**Supplemental Information Letter**  
**Black River-Lorain & Carlisle-Lorain 138 kV Transmission Lines**  
**Reconductor & Rebuild Project**  
**Case No. 16-1180-EL-BLN**

SUPPLEMENTAL EXHIBIT 1

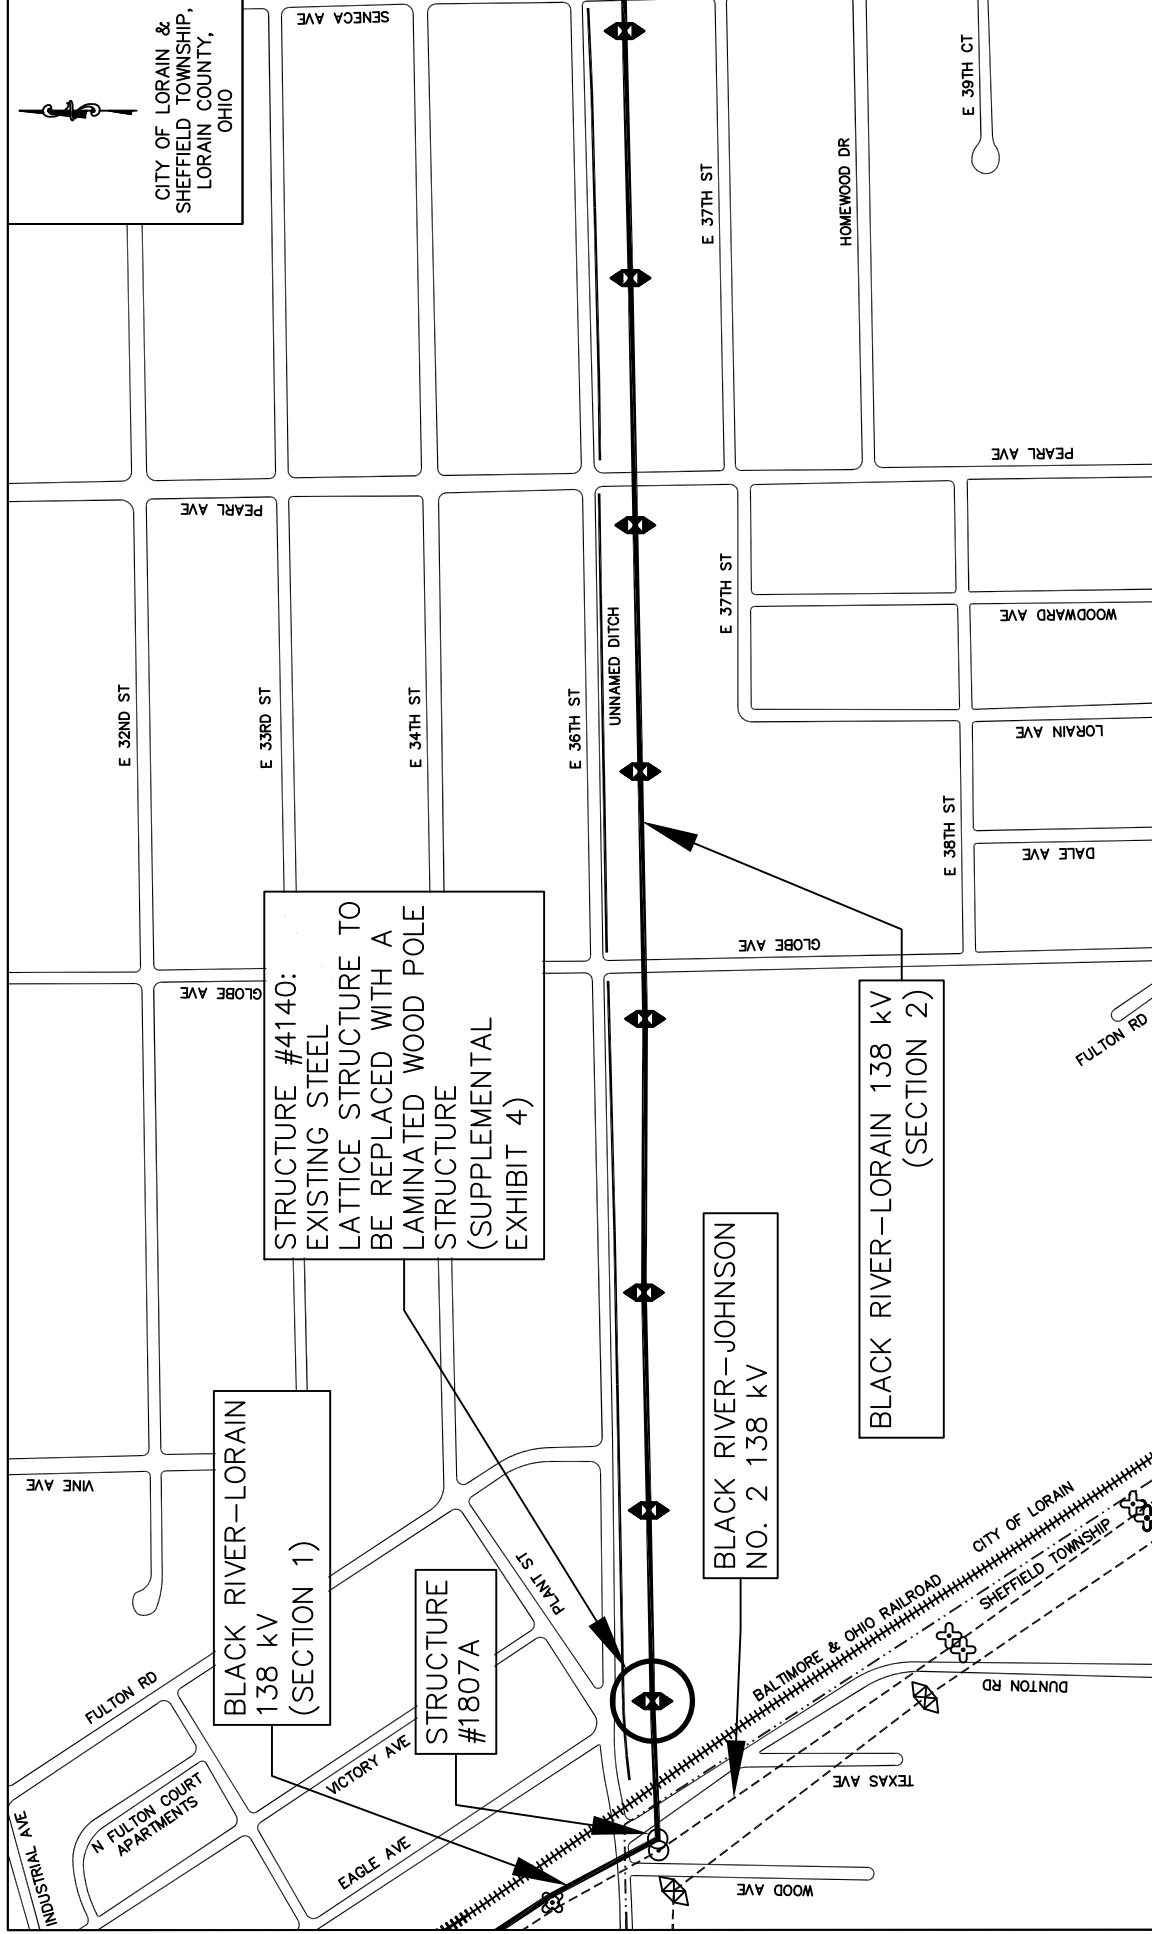
1. Structure #4140, as shown in Supplemental Exhibit 1, will be re-built as a single circuit laminated wood tangent structure, as depicted in Supplemental Exhibit 4, replacing the existing steel lattice structure. This change is necessary because of restrictions in the original easement with the railroad. The original filing called for a single circuit 3-pool wood deadend structure. The revised structure type will have no more impacts than the single circuit 3-pool wood deadend structure.

SUPPLEMENTAL EXHIBIT 2

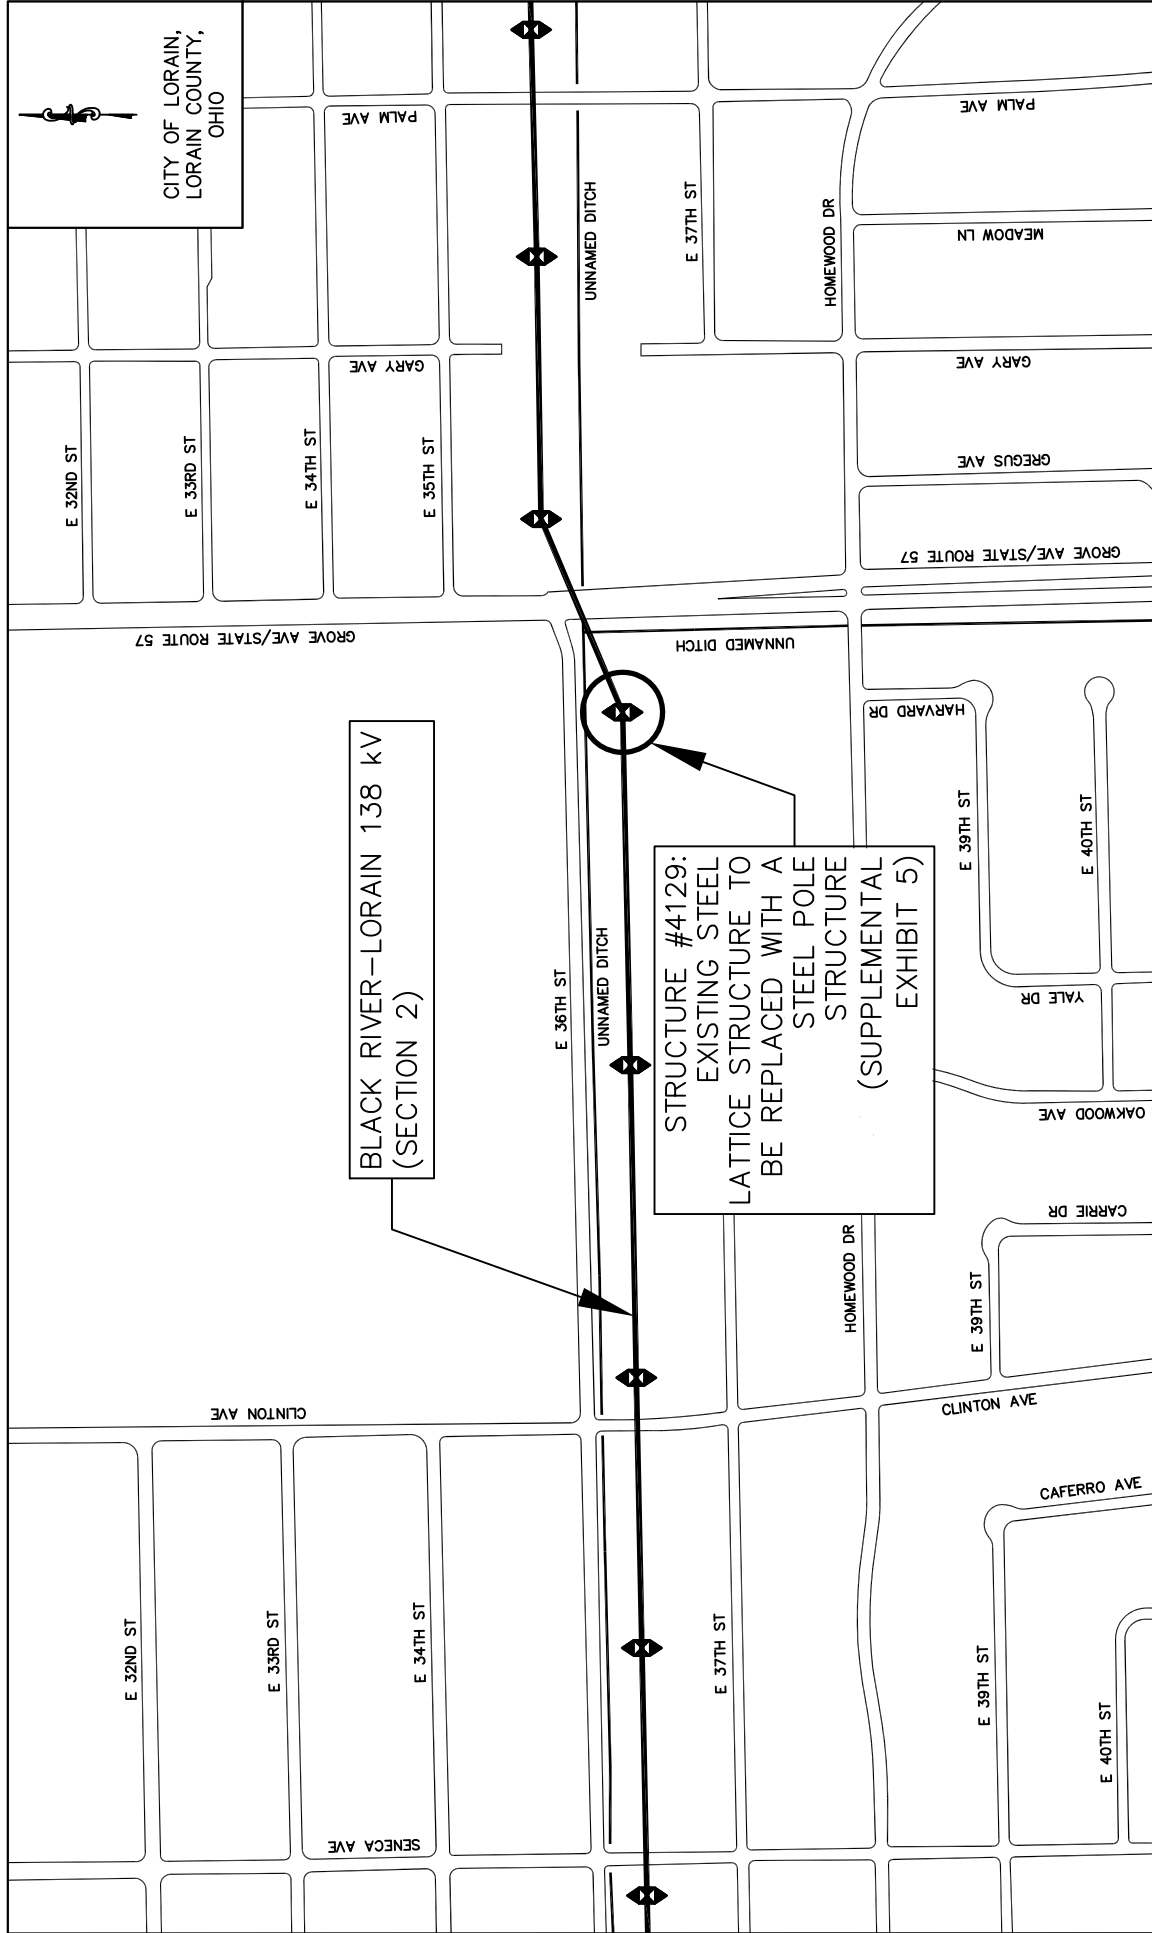
2. Structure #4129, as shown in Supplemental Exhibit 2, will be a re-built as a single circuit steel pole deadend structure with a concrete foundation, as depicted in Supplemental Exhibit 5, replacing the existing steel lattice structure. The proposed replacement structure will be located approximately 15 feet to west of the structure being removed. The proposed structure is located on Church property and the above mentioned engineering changes result in less impact to the property owner and no impacts to wetlands or sensitive areas. The original filing called for a single circuit 3-pool wood deadend structure.

**SUPPLEMENTAL EXHIBIT 3**

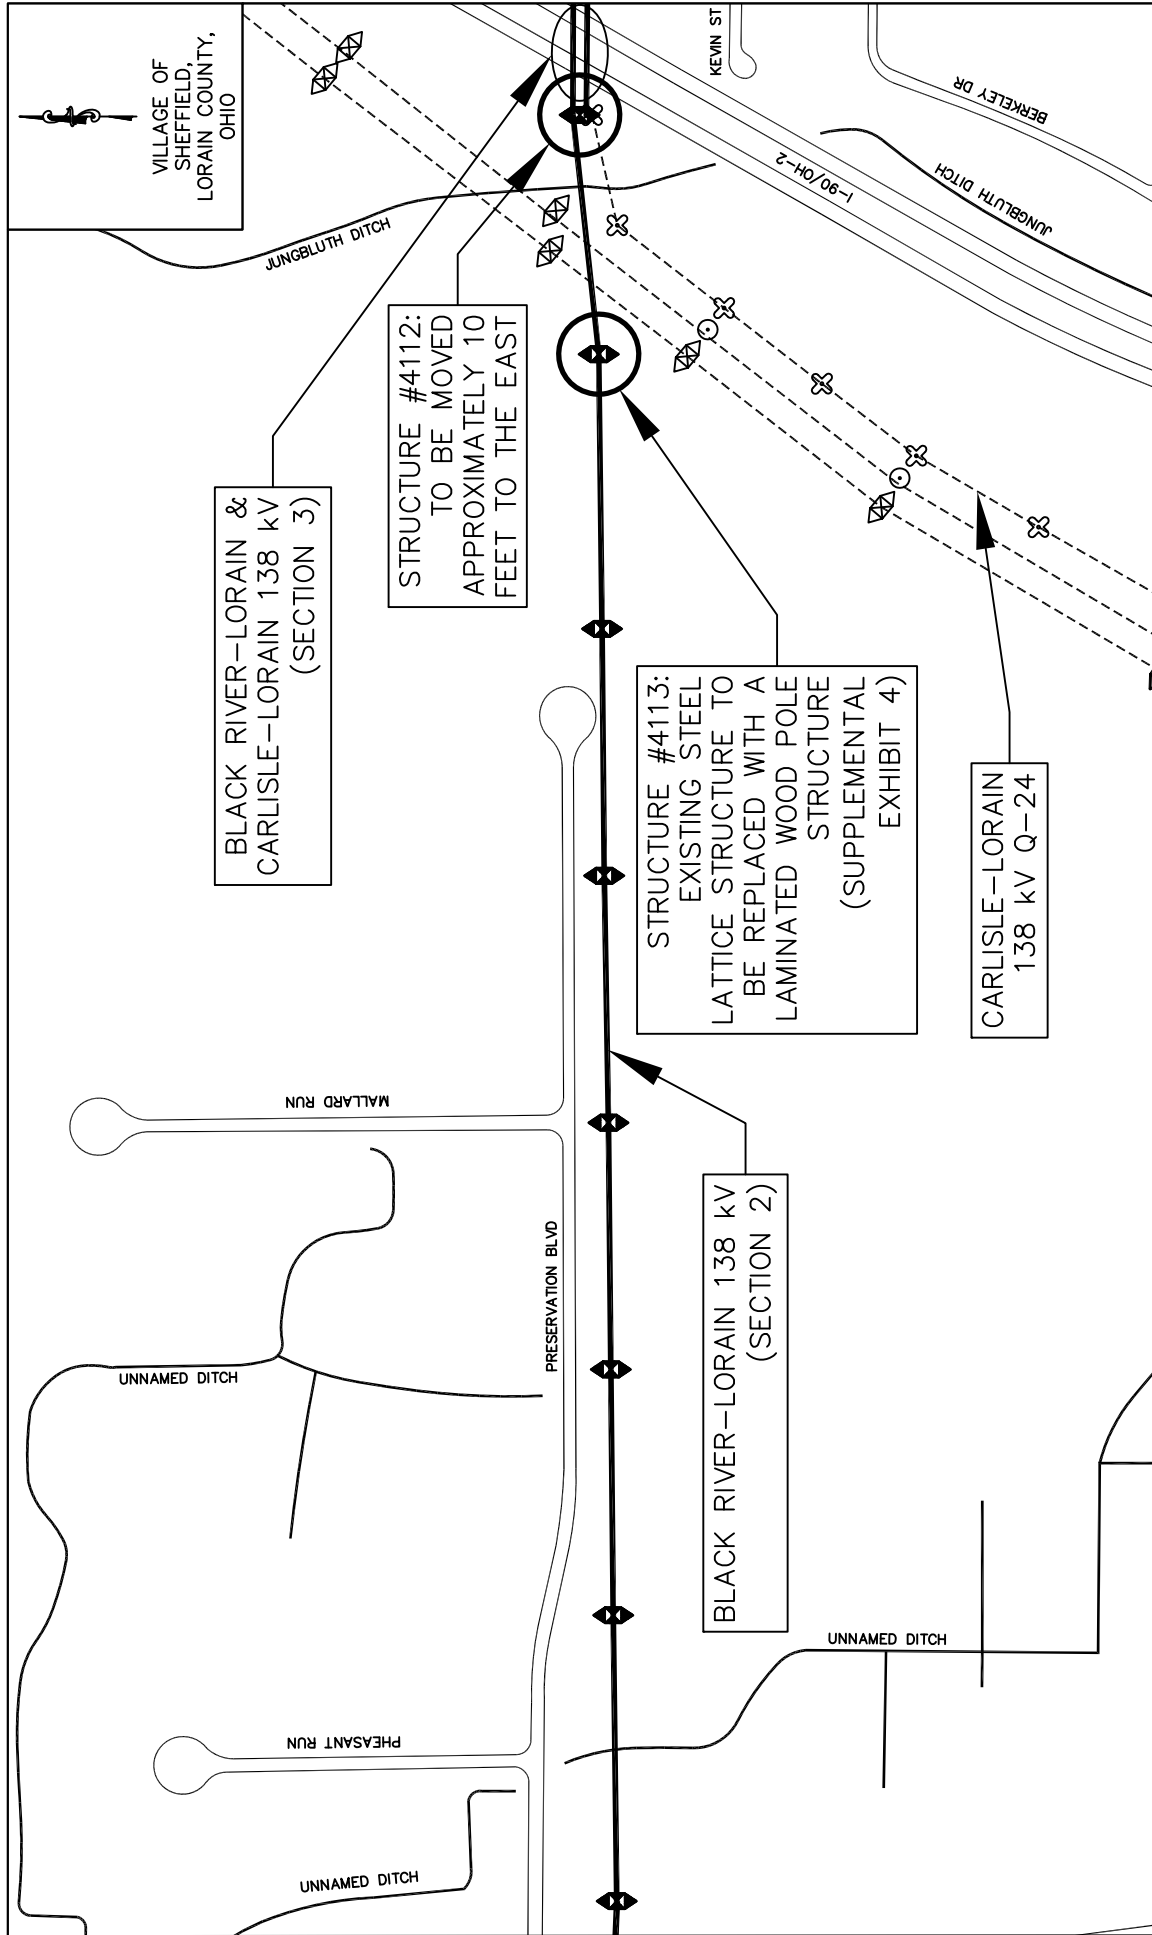
3. Structure #4113, as shown in Supplemental Exhibit 3, will be re-built as a single circuit laminated wood tangent structure as depicted in Supplemental Exhibit 4, replacing the existing steel lattice structure. This change is necessary because of restrictions in the original easement. The original filing called for a single circuit 3-pool wood deadend structure. The revised structure type will have no more impacts than the single circuit 3-pool wood deadend structure.

4. Structure #4112, as shown in Supplemental Exhibit 3, will be placed approximately 10 feet east of the current structure along the existing centerline. The change was made to accommodate foundation construction for the new structure while the lines are still energized. The above mentioned engineering changes results in no additional property owner impacts and no impacts to wetlands or sensitive areas. The structure type has not changed from the original filing.
